SUBJECT: ISSUANCE OF AMENDMENTS FOR CALVERT CLIFFS NUCLEAR POWER PLANT
UNIT NO. 1 (TAC NO. M95181) AND UNIT NO. 2 (TAC NO. M95182)

AMENDMENT NO. 222 TO FACILITY OPERATING LICENSE NO. DPR-53-CALVERT CLIFFS
UNIT 1

AMENDMENT NO. 198 TO FACILITY OPERATING LICENSE NO. DPR-69-CALVERT CLIFFS
UNIT 2

SAFETY EVALUATION BY THE OFFICE OF NUCLEAR REACTOR REGULATION
RELATED TO AMENDMENT NO. 222 TO FACILITY OPERATING LICENSE NO. DPR-53
AND AMENDMENT NO. 198 TO FACILITY OPERATING LICENSE NO. DPR-69
BALTIMORE GAS AND ELECTRIC COMPANY
CALVERT CLIFFS NUCLEAR POWER PLANT, UNIT NOS. 1 AND 2
DOCKET NOS. 50-317 AND 50-318

FIGURE 3.1.1-1
FRACTION OF RATED THERMAL POWER
VS. ALLOWABLE POSITIVE MTC LIMIT ($10^{-4} \Delta \rho / F^{\circ}$)

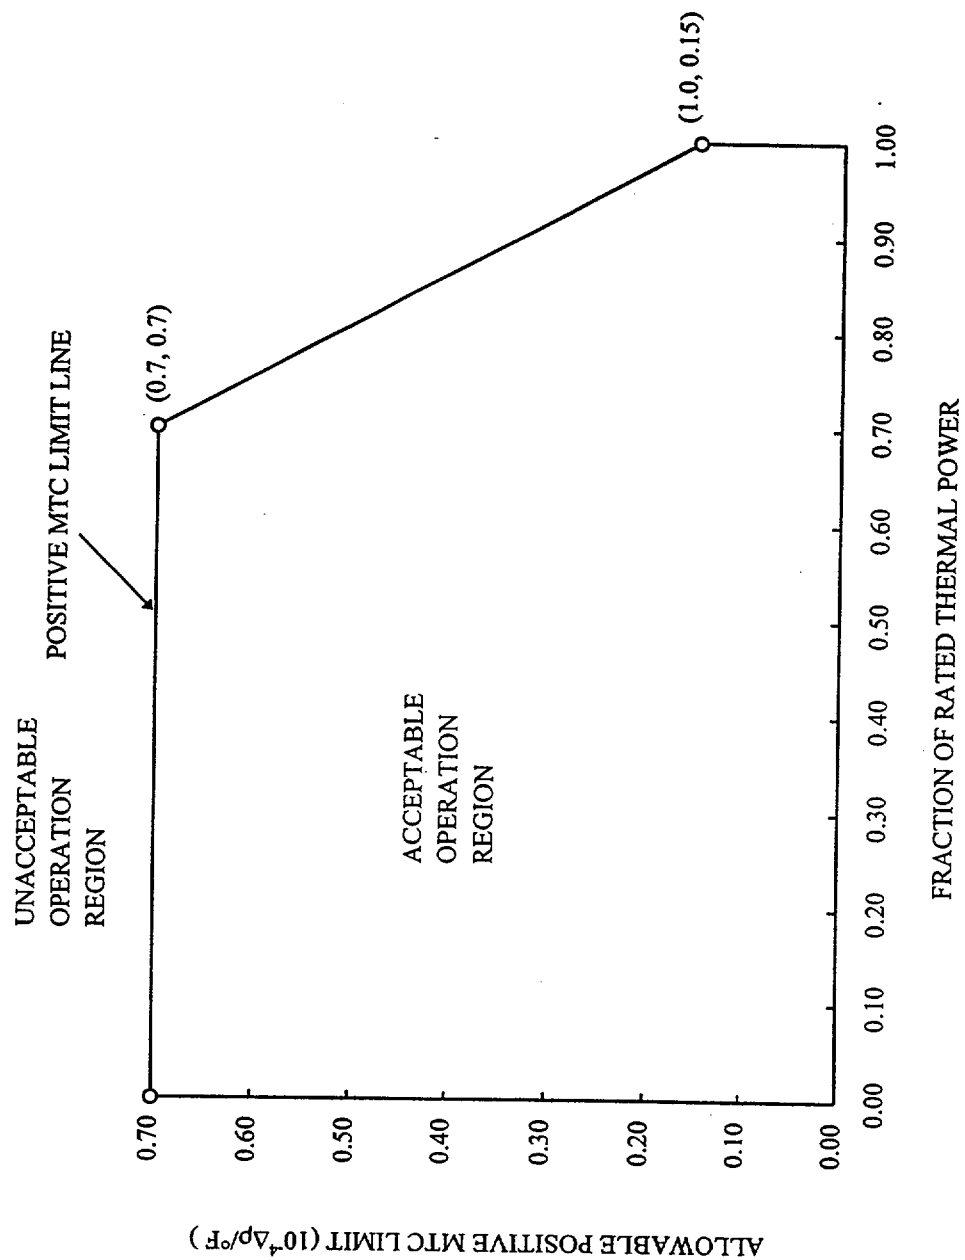
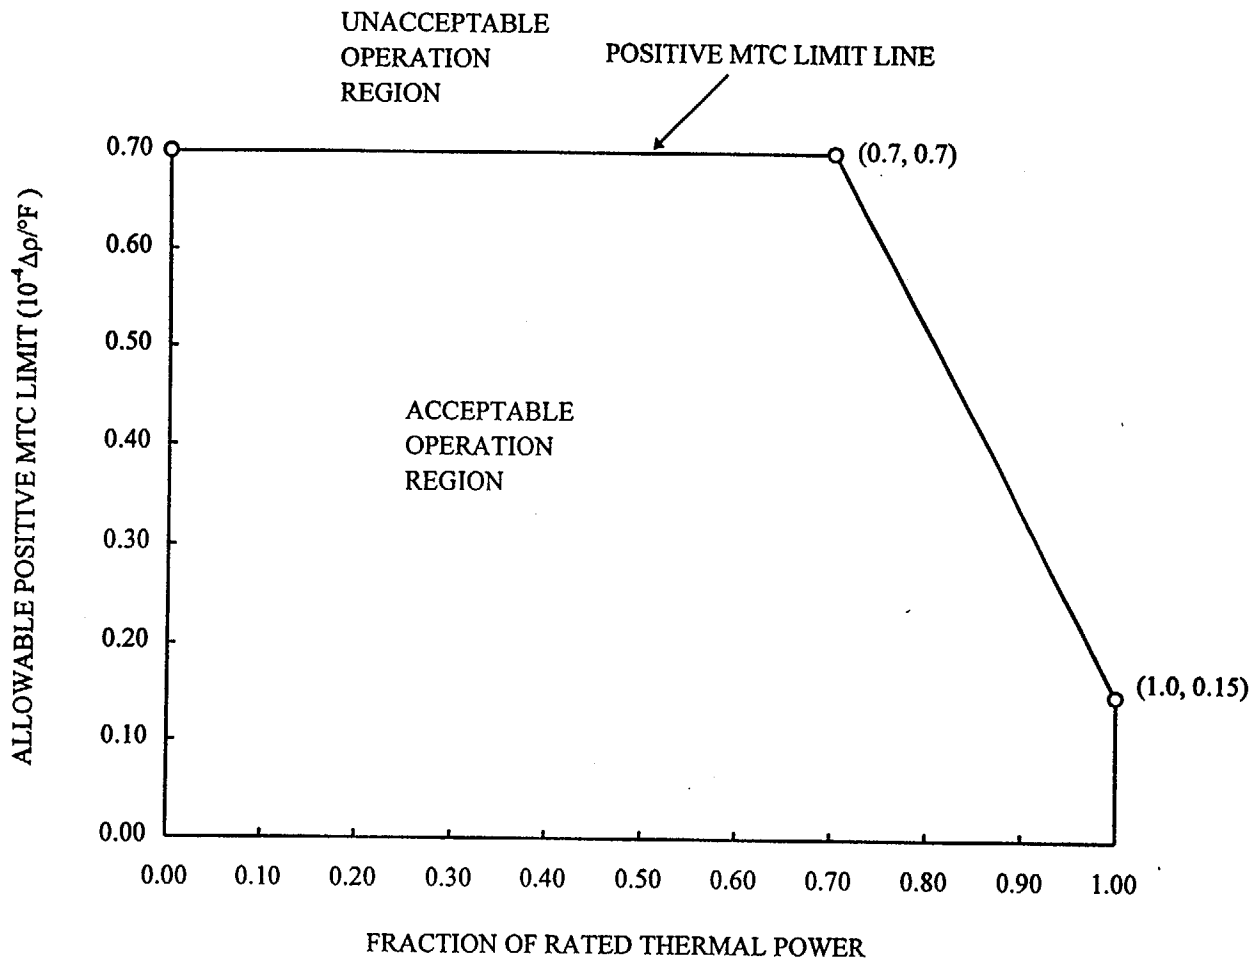
The amendments reduce the moderator temperature coefficient (MTC) limit shown on TS Figure 3.1.1-1. This proposed change is necessary to support changes in the safety analyses made to accommodate a larger number of plugged steam generator tubes for future operating cycles. You also provided information to clarify the relationship of MTC to the anticipated transient without scram event in their licensing basis.

The possibility of increasing the number of plugged SG tubes at Calvert Cliffs has necessitated the change to the TS Figure 3.1.1-1. The safety analysis for the Calvert Cliffs current cycle assumes 500 tubes per SG are plugged and the maximum beginning-of-cycle MTC is assumed to follow Figure 3.1.1-1.

Increasing the number of tubes plugged will reduce the calculated heat transfer heat area from the reactor coolant system (RCS) to the secondary side of the SG. This reduction in heat transfer will result in an increased RCS temperature and pressure during plant heat up events such as loss of feedwater, feed line break, etc. In order to mitigate the RCS pressure and temperature increase for these events with increased number of plugged SG tubes, the licensee found it necessary to request a TS change to Figure 3.1.1-1, reflecting a more restrictive (less positive) limit on the maximum

positive MTC when analyzing the heat up events. From a safety point of view, a less positive MTC will result in a reduced core reactivity during plant heatup events, and the reduced core reactivity will mitigate the increased RCS temperature and pressure during these events. Also, the proposed change will make the limit on the maximum positive MTC less positive. From an operational standpoint, a more restrictive MTC limit will help mitigate the effects of plant transients on control of plant parameters (e.g., reactor power, pressurizer pressure, pressurizer level, etc.)

A less positive MTC will ensure that the assumptions used in the accident analyses affected by the change remain valid for each fuel cycle. Those accidents affected by the change are Loss of Load, Loss of Feedwater, Feed Line Break, and Control Element Assemble Withdrawal events. These analyses were reanalyzed using approved methodologies to determine the effect of the change in the number of plugged SG tubes. The results of the reanalyzed events remain within the previously approved limits. Also the decrease (more negative) in the MTC limit more than offsets the effects of the increased number of plugged SG tubes. The proposed change to the allowable MTC limits as indicated on TS Figure 3.1.1-1 will be more restrictive to reflect the assumptions used in the events listed above.

The staff has reviewed the licensee's proposed TS changes for Calvert Cliffs Nuclear Power Plant, Unit Nos. 1 and 2. Based on the staff's evaluation of the submittal of March 28, 1996, and the responses to request for additional information, dated November 20, 1996, and July 31, 1997, the staff approves the TS change to Figure 3.1.1-1 for Calvert Cliffs Nuclear Power Plant, Unit Nos. 1 and 2. The proposed change makes the limit on the maximum positive MTC more restrictive. From an operational standpoint, a more restrictive limit on MTC will help mitigate the effect of plant transients of control of plant parameters (e.g., reactor power, pressurizer pressure, pressurizer level, etc.) Therefore, the previously analyzed accident will be significantly increased and the staff finds this change acceptable.
